Infonote

AO-IN-2026-029-I

Introduction of improved carrier tape for Chip LED product family

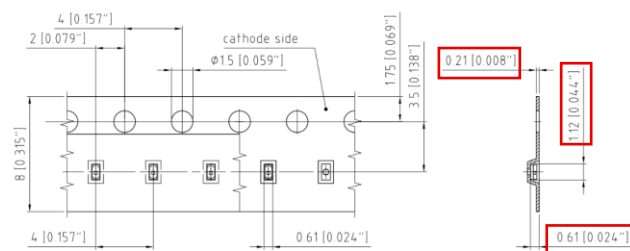
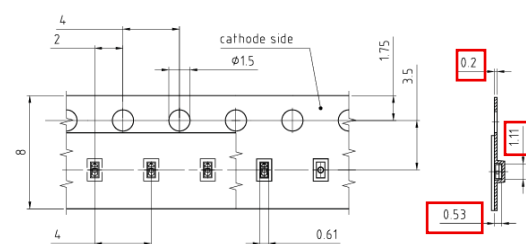
Objective:	Introduction of improved carrier tape for Chip LED product family
Affected products:	SFH 4043, SFH 4043B, SFH 4053, SFH 4053B
Reason for change:	Introduction of improved carrier tape design to reduce risk of slanting in tape: slight reduction of pocket size.

Current statusTaping ¹⁰⁾

Description of change:**New status**Taping ¹⁰⁾

Time Schedule:	Implementation of improved carrier tape: SFH 4043 / SFH 4053: CW 24 / 2026 SFH 4043B / SFH 4053B: CW 21 / 2026
Assessment:	There is no change of the affected LEDs. No change in carrier tape material or other dimensions of the taping.
Documentation:	The tape drawing in the datasheet is updated accordingly. The inch values are removed from the drawing.
